Peer Review of Flood Assessment for Club Punchbowl Planning Proposal

Prepared for Canterbury Bankstown Council

Reference no. 300204010 | 18 March 2024

Figure 4-1 TUFLOW Roughness Mapping for the Subject Site and Surrounds (Source: BMT-WBM, 2009)

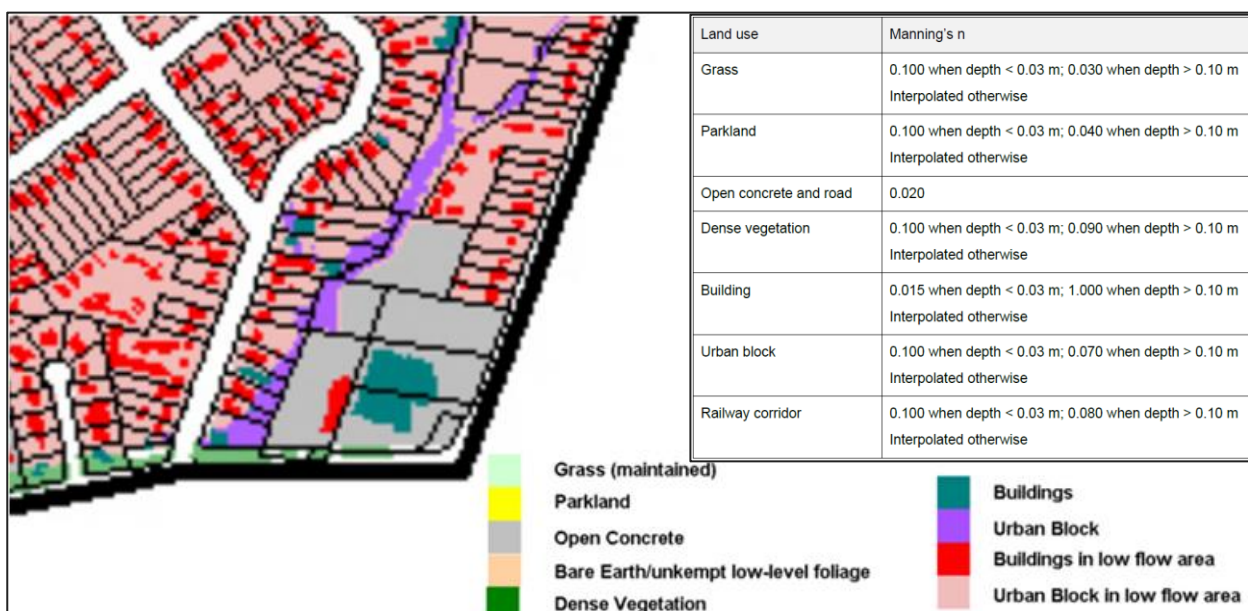
- > Hydraulic roughness was retained from the Council model, with the roughness mapping for the subject site and surrounds extracted from the 2009 Flood Study (BMT-WBM, 2009) shown in **Figure 4-1**. Though not originally reported, confirmation was provided within Ref 9 from Hydracor Consultants that this roughness mapping was not altered aside from some updated building footprints around the site.

Generally, Stantec would concur with noted comments from previous Council RFI's that both the upstream (eastern) and downstream (southern) model boundaries are too close to the subject site. This would normally expose the assessment to too much uncertainty regarding appropriate routing of modelled flows and impacts.

- > Fully block buildings from the model rather than raised 0.5 metres only (as noted within a previous RFI from Council discussed in Ref 4)
- > Confirming if upstream flows to the east are double counted within the current model set-up.

- > Assessing through a sensitivity model the impacts of including the brick wall around the perimeter of the site in the existing case either as a strip of high roughness or as a 2D terrain modification.

Figure 4-6 Flood Provisional Hazard Categories – Post-development 1% AEP Event

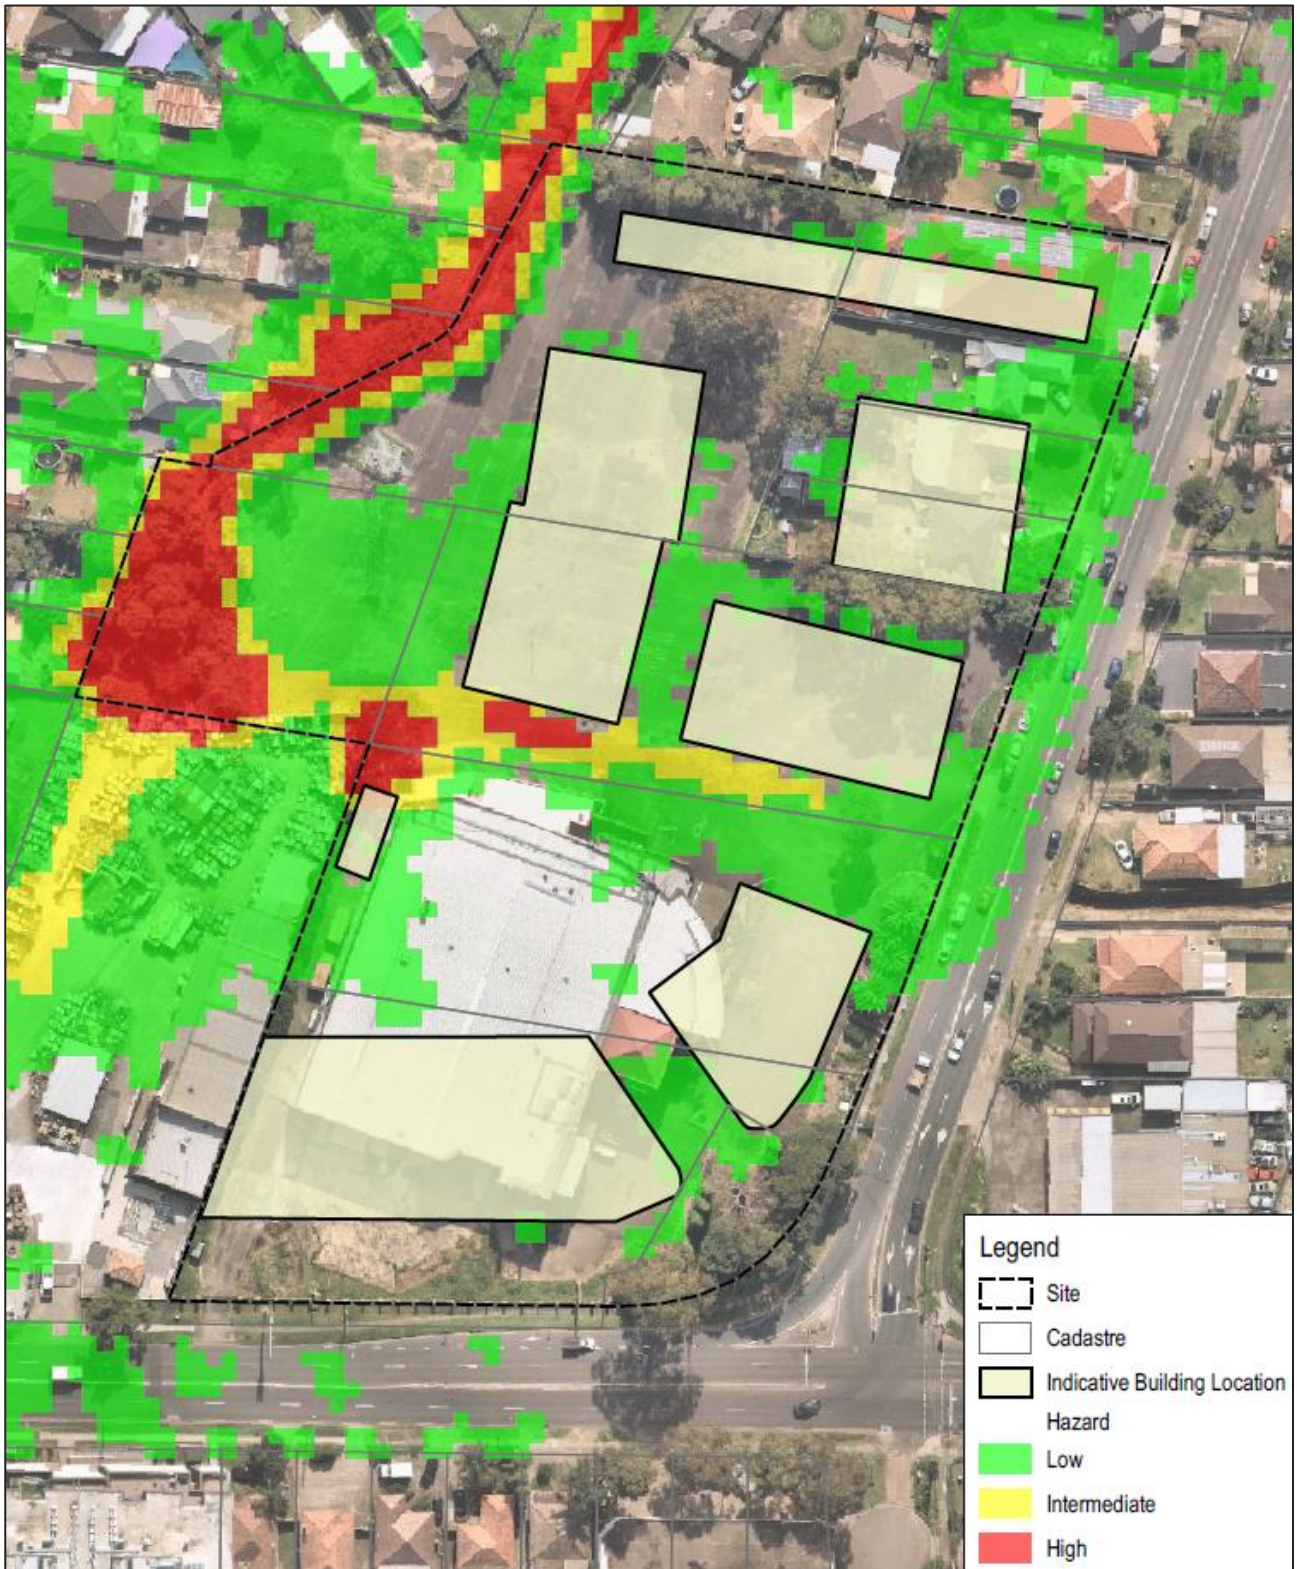
The provisional flood hazard of the proposed development for the 1% event is shown in **Figure 4-6** (extracted from Ref 10). The results show that the majority of the site is classed as low hazard in a 1% AEP event. Within the proposed road reserve through the centre of the site there is some intermediate hazard affectation, with isolated sections of high hazard affectation on the central-western side of the site.

Direction Provision	Consistent with Direction Provision
c) permit development for the purposes of residential accommodation in high hazard areas,	c) As shown in Figure 4-6 , the 1% AEP high hazard has been maintained through the centre of the site through the alignment of the central road proposed. There is high hazard close to Building A and D, however the addition of design surface to modelling in later stages is expected to be able to address this proximity to high hazard.

Figure 4-7 Flood Hazard Categories H1-H6 – Post-development 1% AEP Event

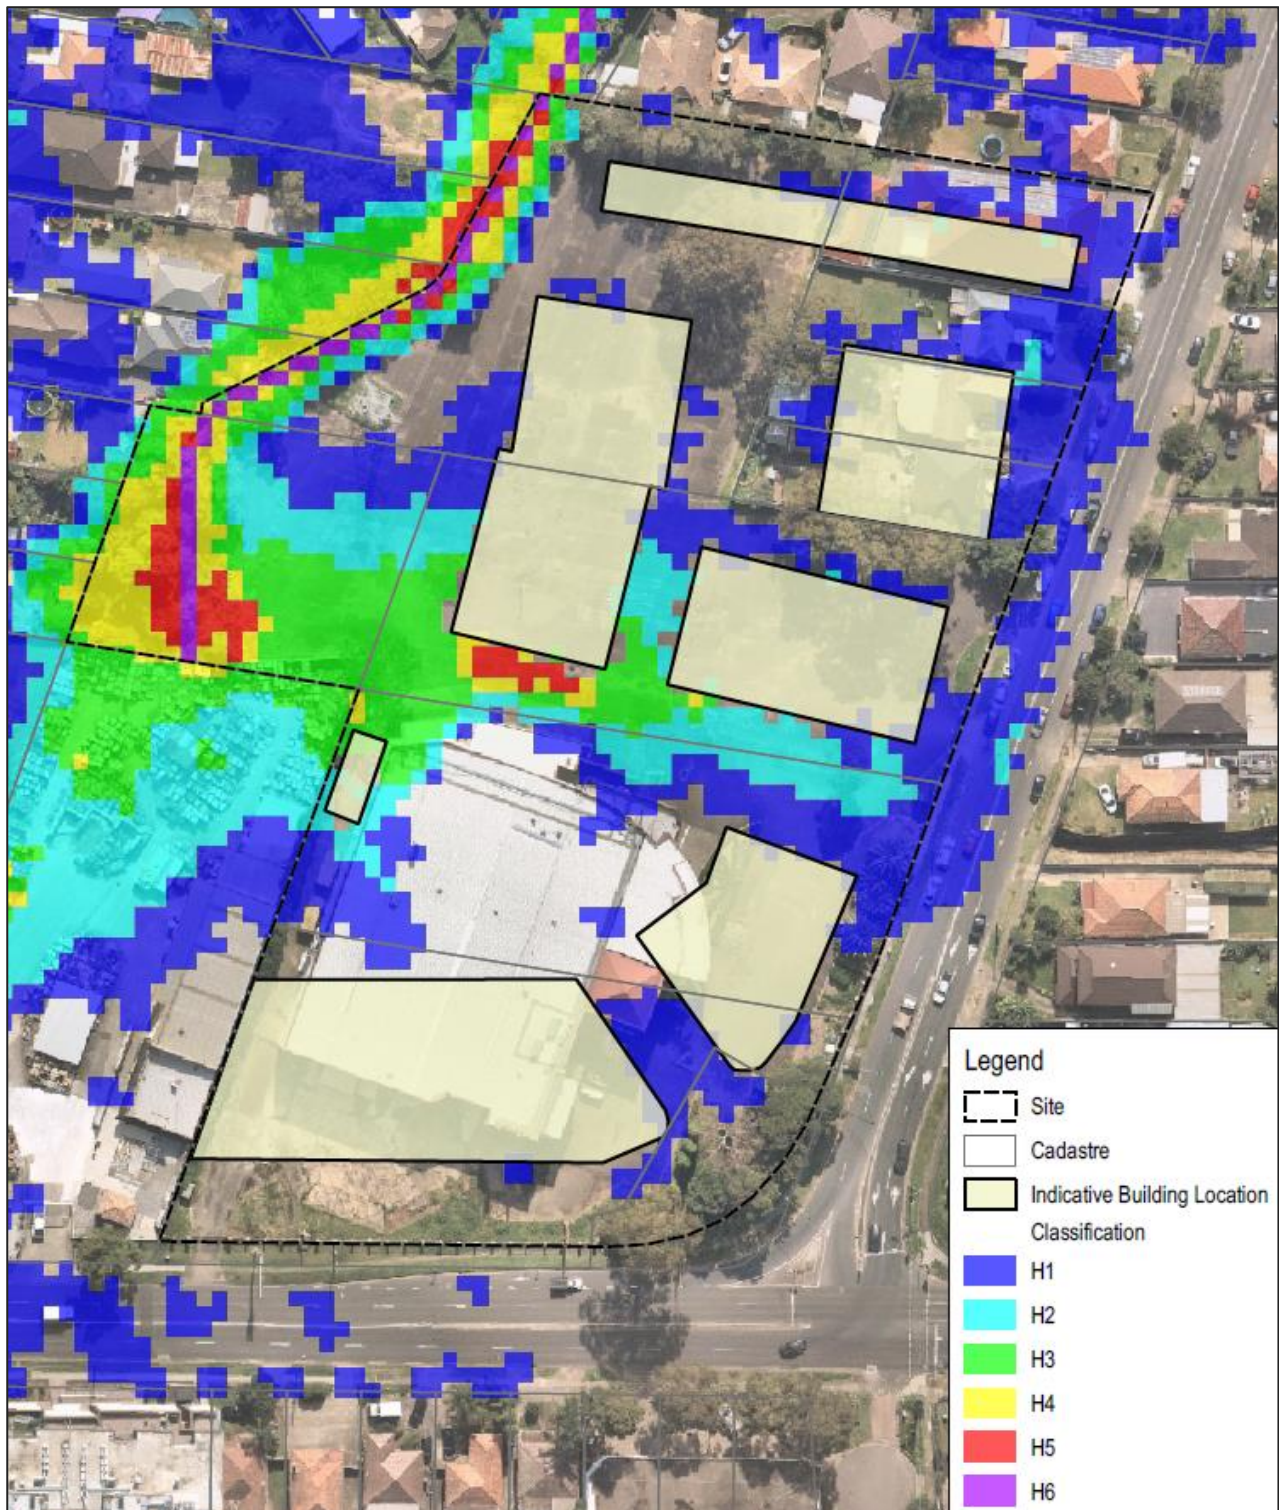
The H1-H6 hazard maps show that in the 1% AEP there is H3 hazard within the central road reserve with isolated areas of up to H5 hazard near Building A. However it is assumed this isolated section of high hazard can be suitably addressed in civil design of the site during later development stages.

Figure 4-8 Flood Hazard Categories H1-H6 – Post-development PMF Event

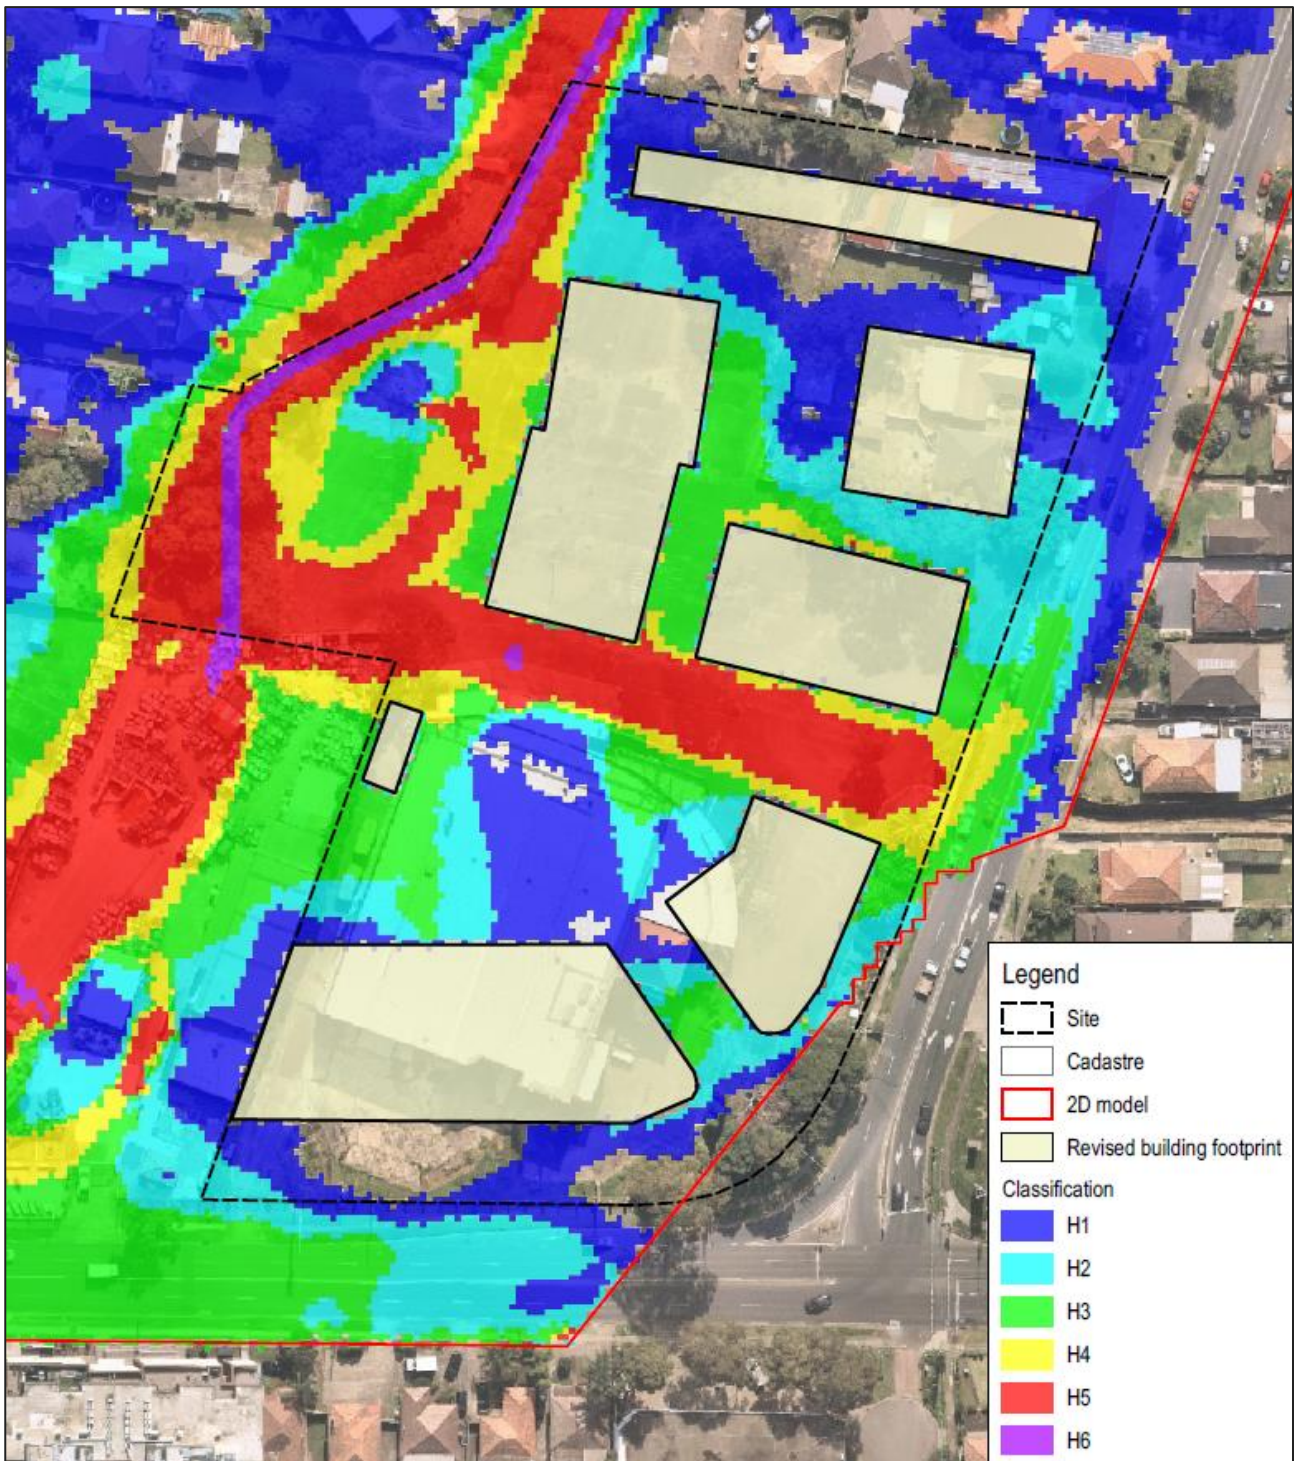
In the PMF event the central road corridor is H5 hazard along its entire length making it not a suitable flowpath. As noted above, there are some PMF H5 hazard areas up against proposed buildings, however a civil design could reasonably divert flooding away from these buildings to be resolved in future development stages.

- > The H1-H6 hazard in the PMF event shown **Figure 4-8**, the western portion of the site is classed as H5 hazard meaning structural stability may be compromised in a PMF event. Therefore assuming shelter-in-place were the adopted emergency response (as the flash flooding nature of this floodplain suggests that evacuation will be difficult), then SIP refuge should not be located on the west side of the site.

Figure 4-9 Flood Function Mapping – Post-development 1% AEP Event

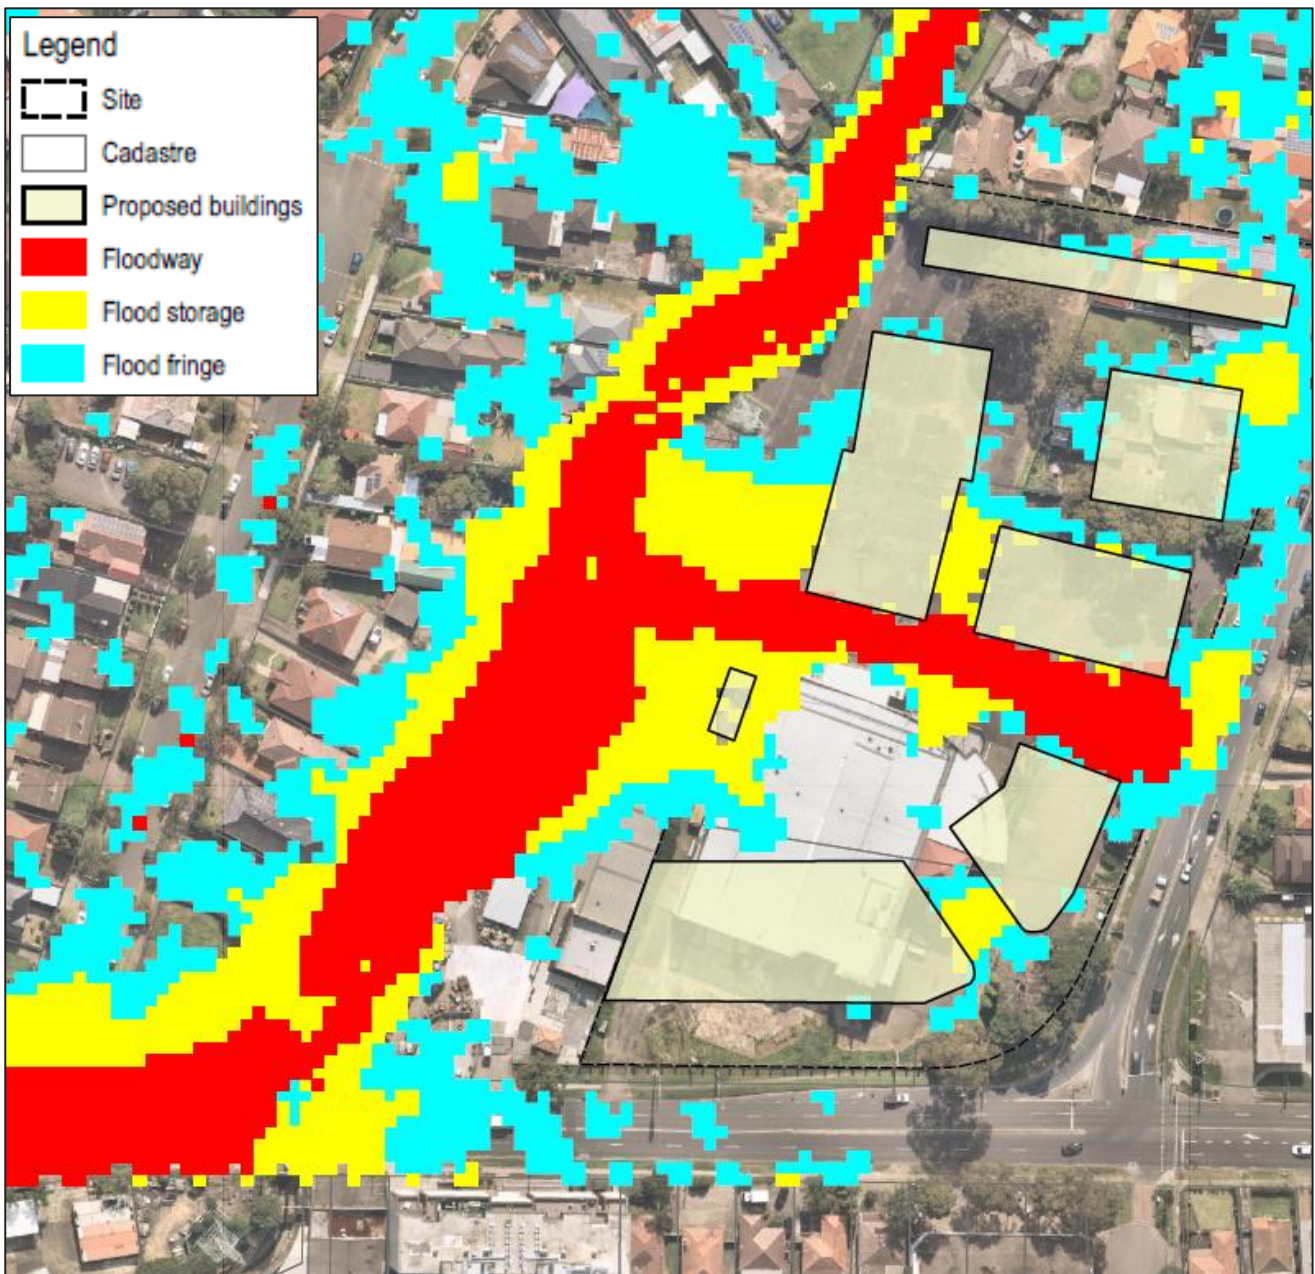
The flood function mapping using the above criteria for the proposed development for the 1% AEP event is shown in **Figure 4-9** (extracted from Ref 8). The results show that the central road proposed for the site is a key floodway in the 1% AEP as well as the western side of the site for the northern flowpath. While Building A and Building D are both near the floodway of the central road, civil design of the site surface should be able to slightly divert floodway away from the buildings. Generally, the site layout maintains a clear floodway for both flowpaths.

- > As shown in **Figure 4-9**, the western side of the 23 Canterbury Road site is affected by 1% AEP floodway, therefore any potential buildings within this portion of the site may cause flow blockage and significant impacts. The eastern portion of the site is mostly flood-free in the 1% AEP and therefore may be suitable for potential development.

a) permit development in floodway areas,	a) As shown in Figure 4-9 , the 1% AEP floodway has been maintained through the centre of the site through the alignment of the central road proposed. There are no major building obstructions proposed in either the eastern or northern flowpaths therefore this condition is considered suitably met. There is floodway close to Building A and D, however the addition of design surface to modelling in later stages is expected to be able to address this proximity to floodway.
